Corrigendum - II dated 18/06/2026 to CPC Tender No. BHEL/CPC/KRD/EPC LHP GHP/27/023

Corrigendum - II dated 18/06/2026 to CPC Tender No. BHEL/CPC/KRD/EPC_LHP_GHP/27/023 for the work of “EPC PACKAGE FOR LIME HANDLING PLANT, GYPSUM HANDLING PLANT AND BOTTOM ASH HOPPER AT 2X660 MW, MSPGCL KORADI THERMAL POWER STATION, UNIT-11& 12, KORADI, NAGPUR, MAHARASHTRA.”

A) Modification in TECHNICAL CONDITIONS OF CONTRACT (TCC): The following clause of existing TCC are revised as below;

Annexure-21 to TCC - Gypsum dewatering building layout

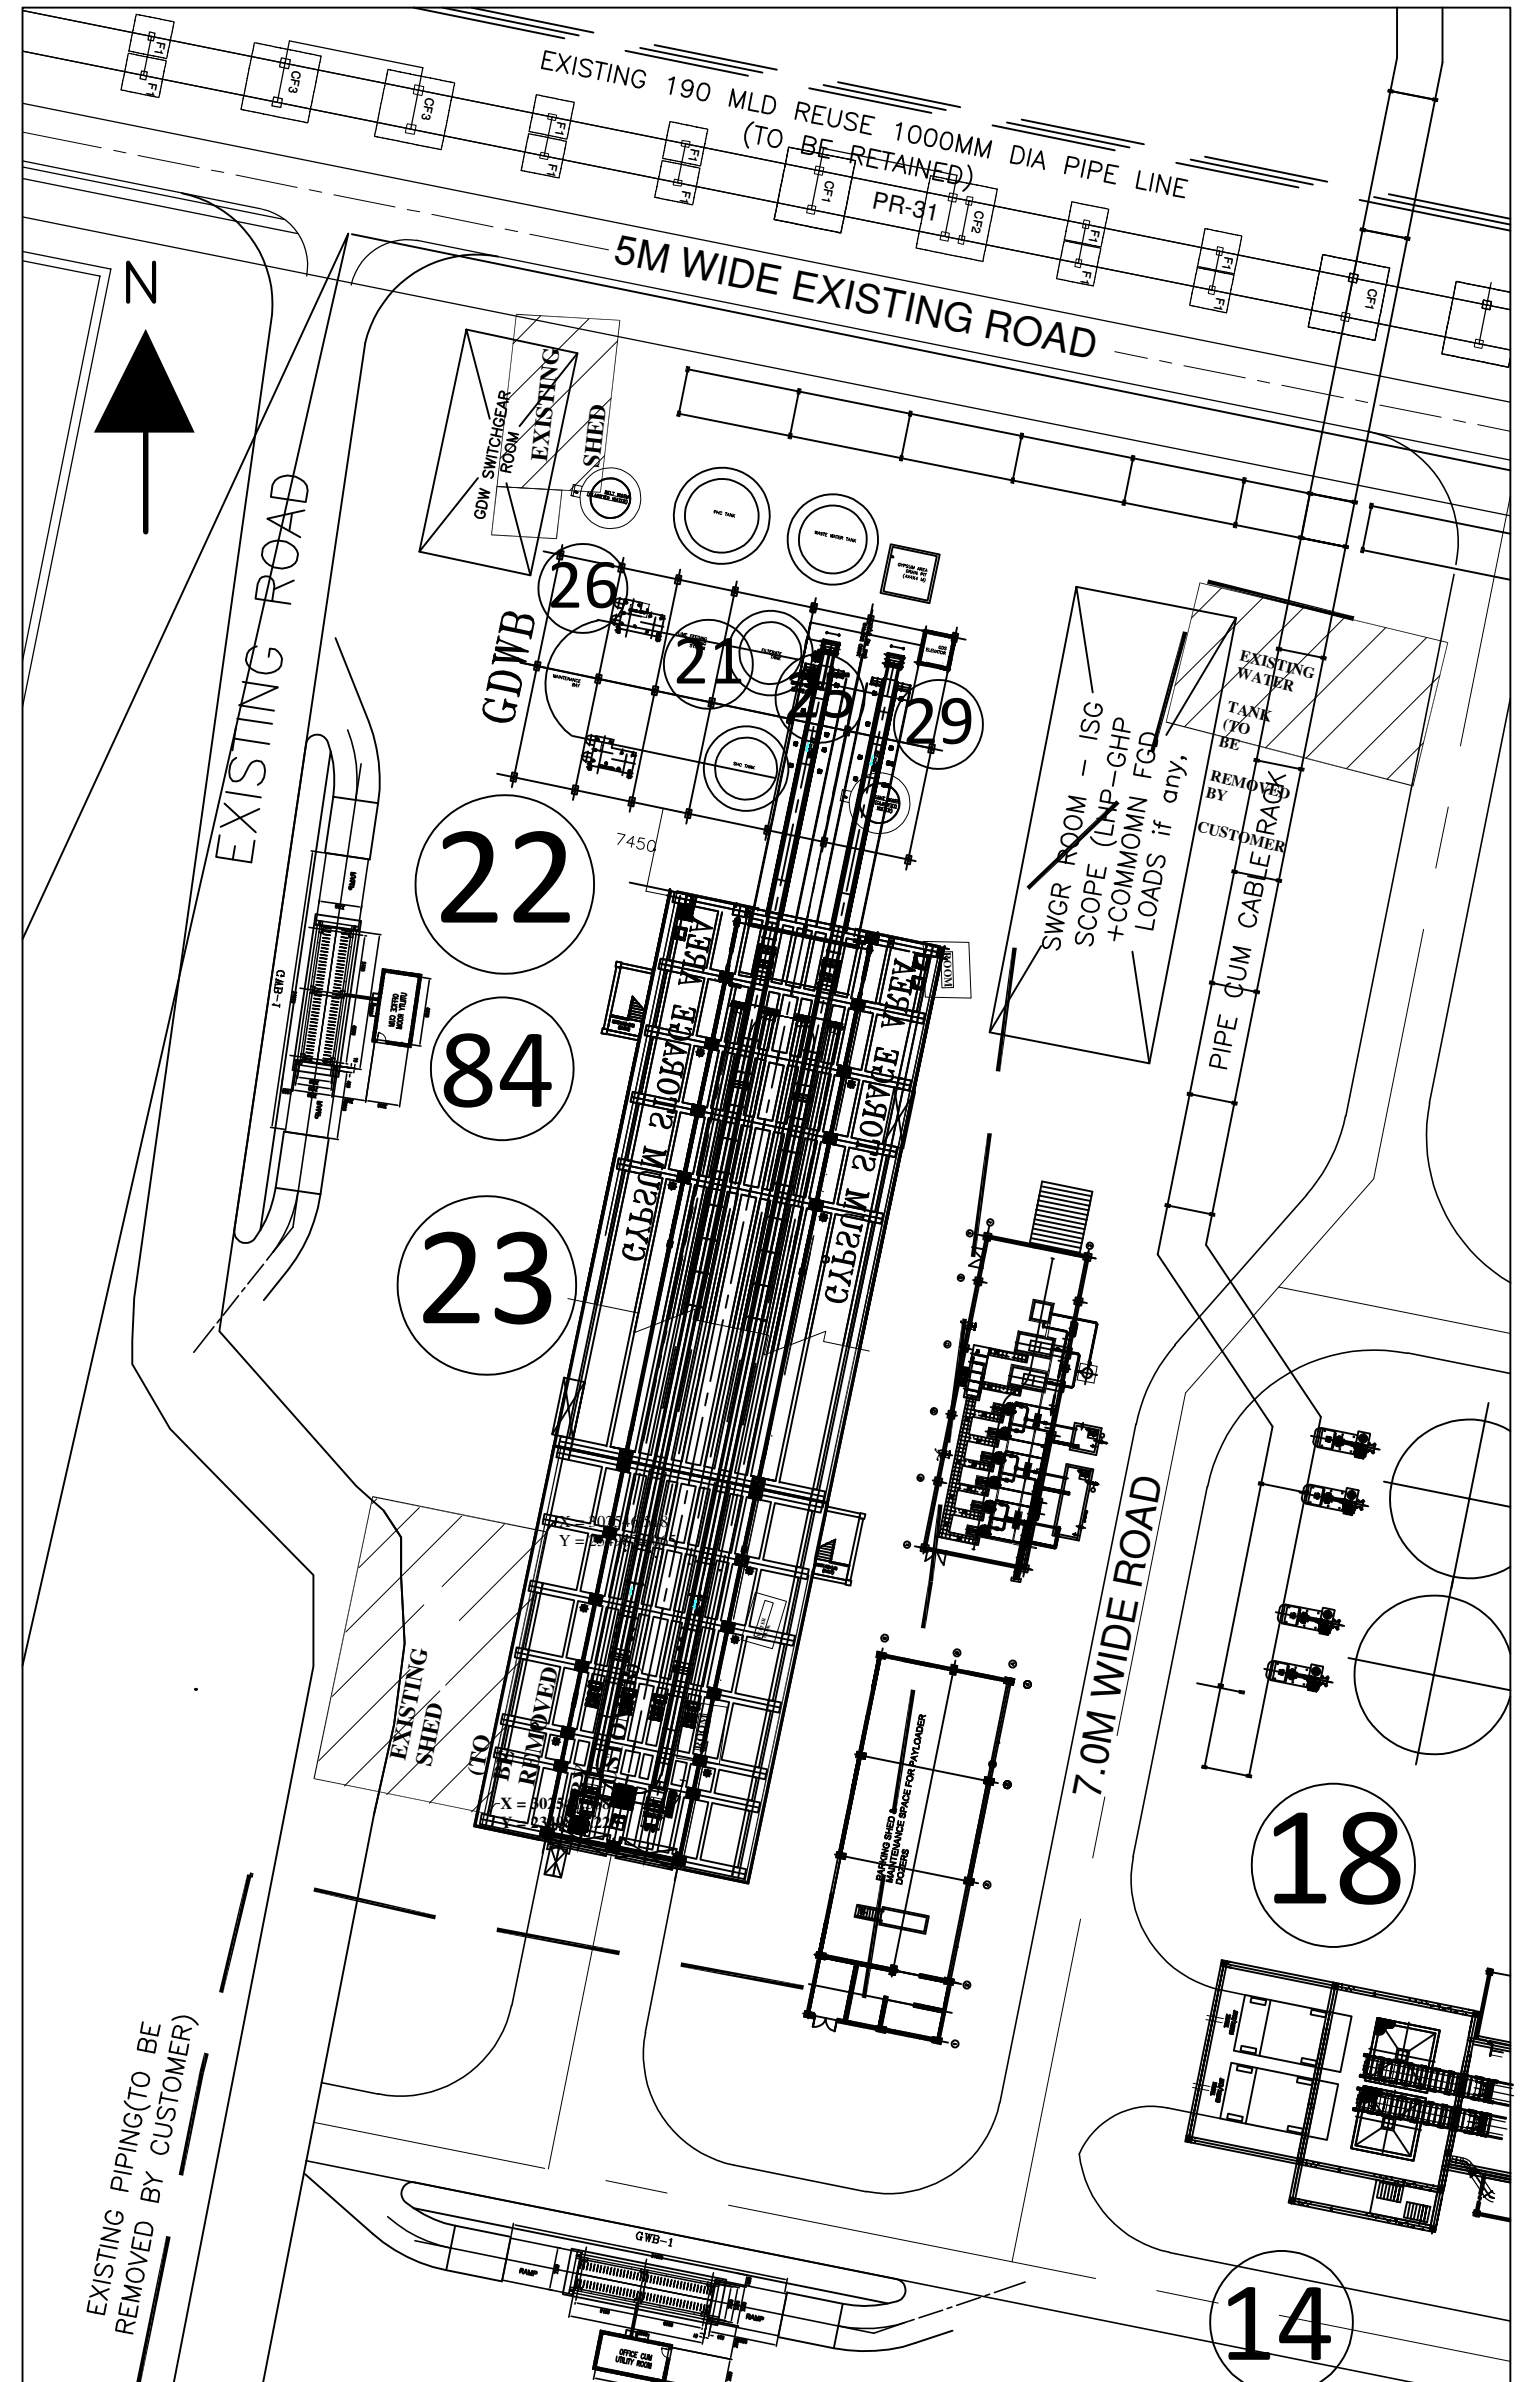
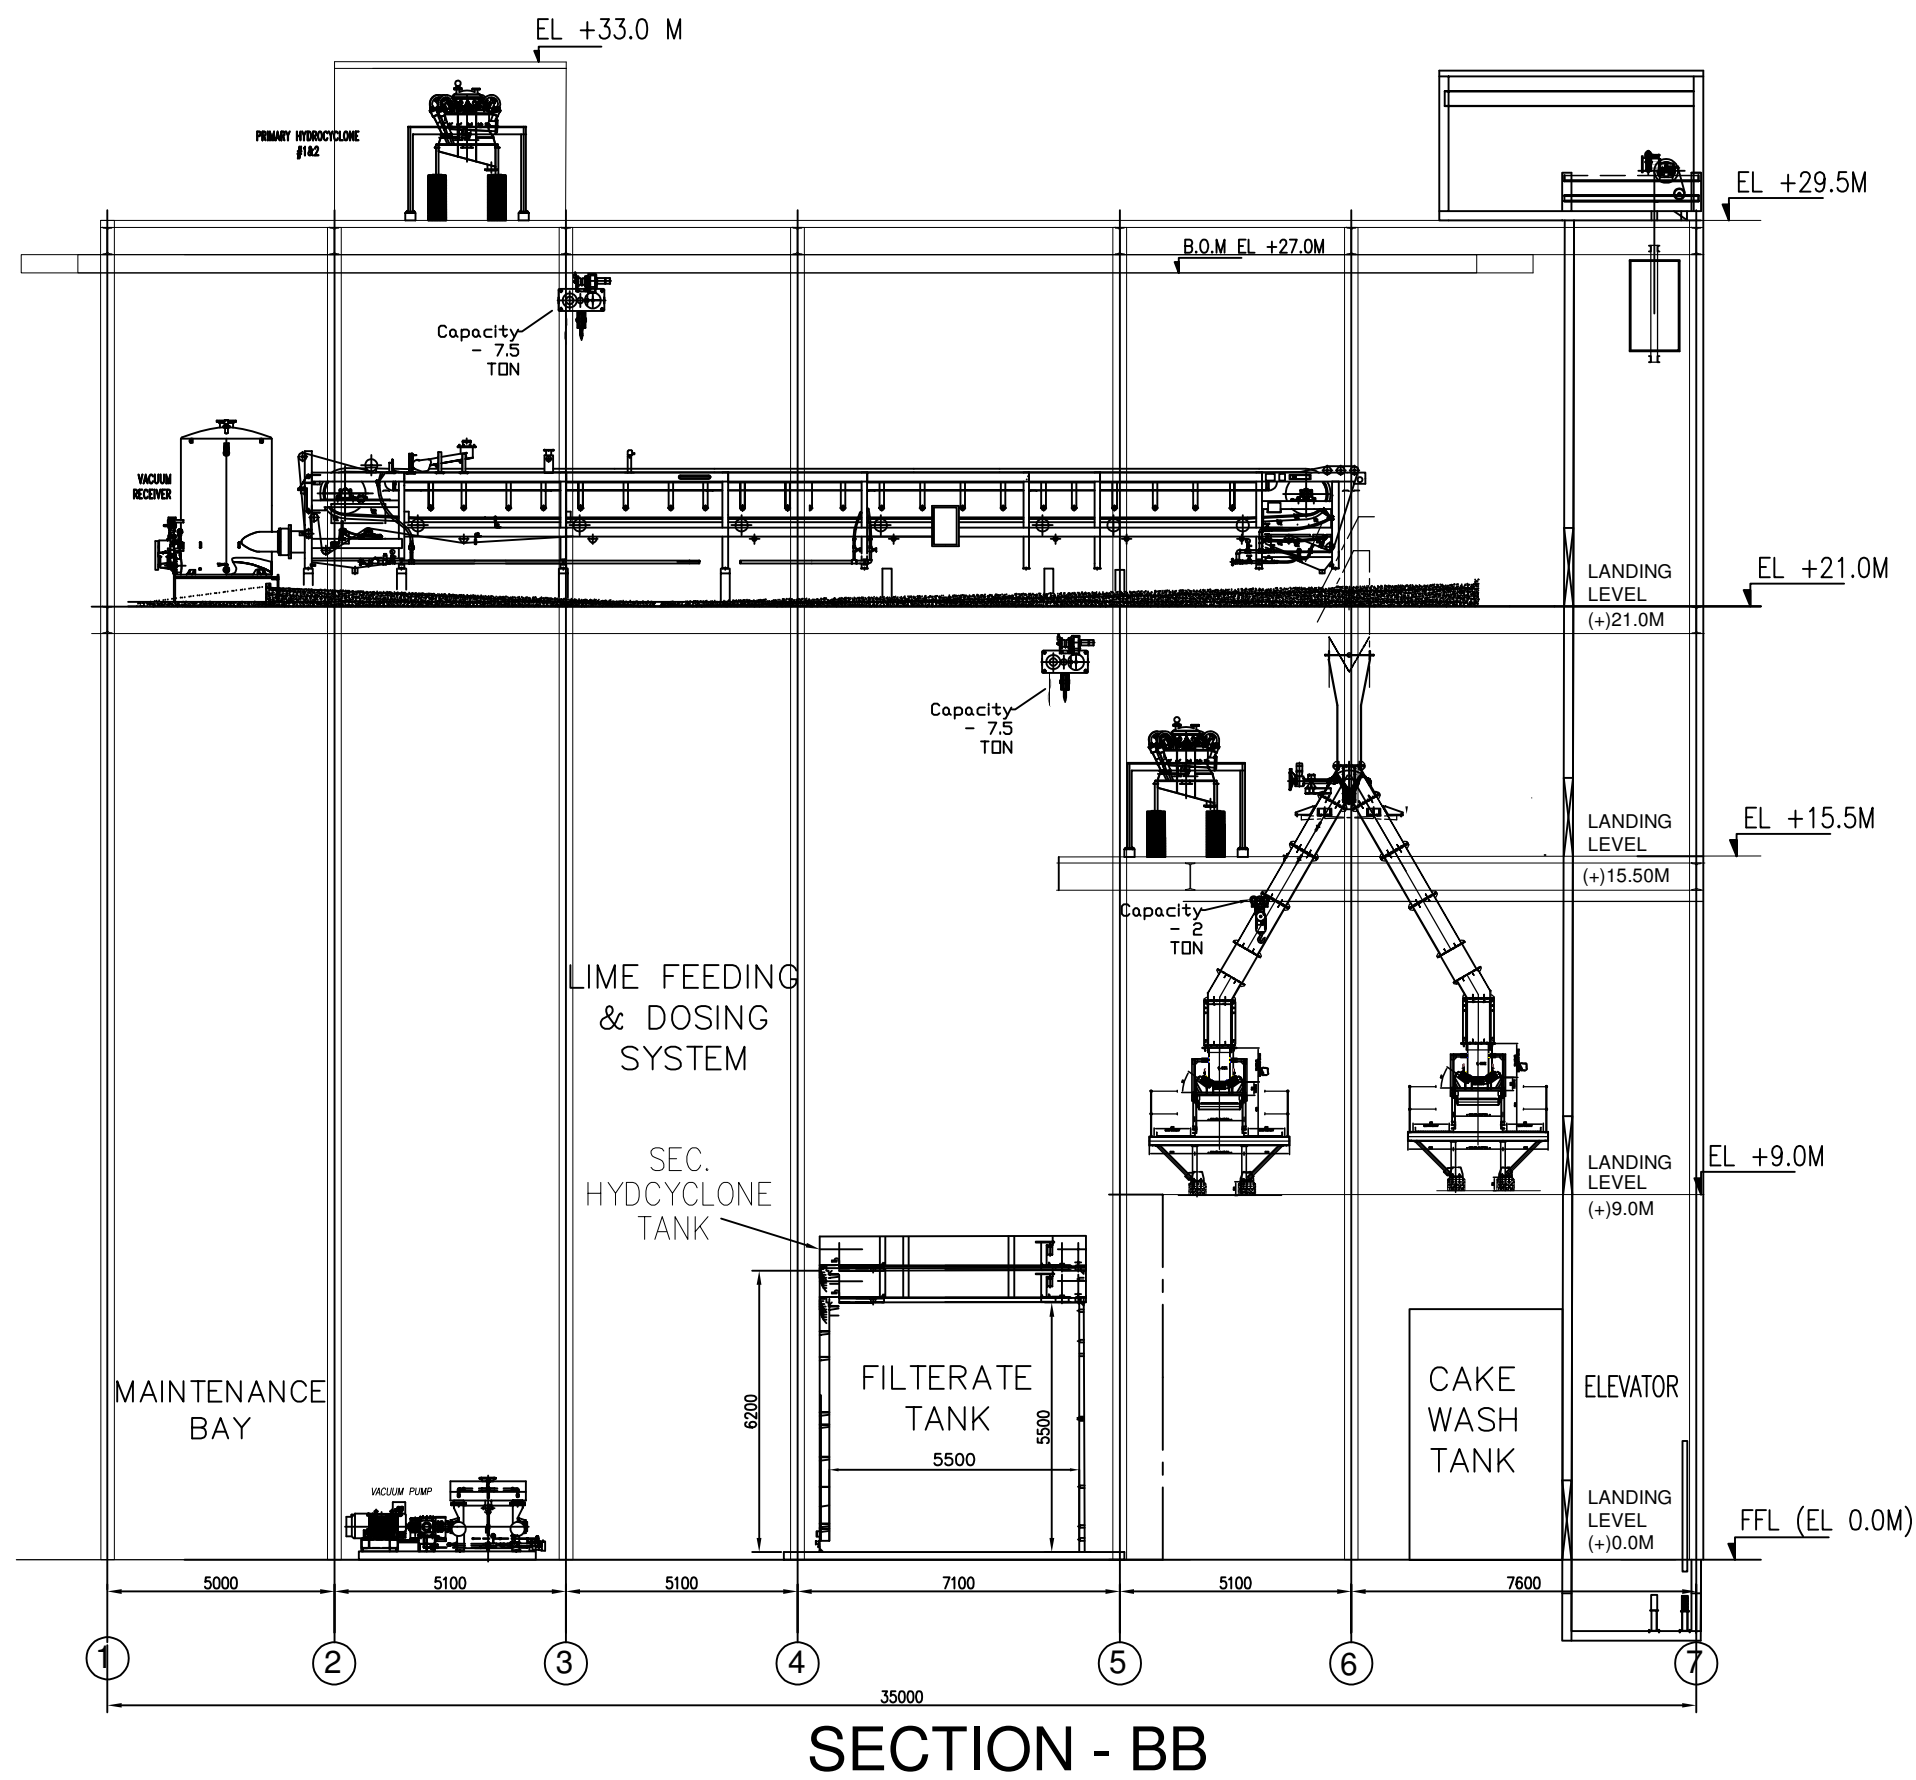
4	TCC, Annexure-21	New Annexure to TCC	Annexure-21 to TCC - Gypsum dewatering building layout
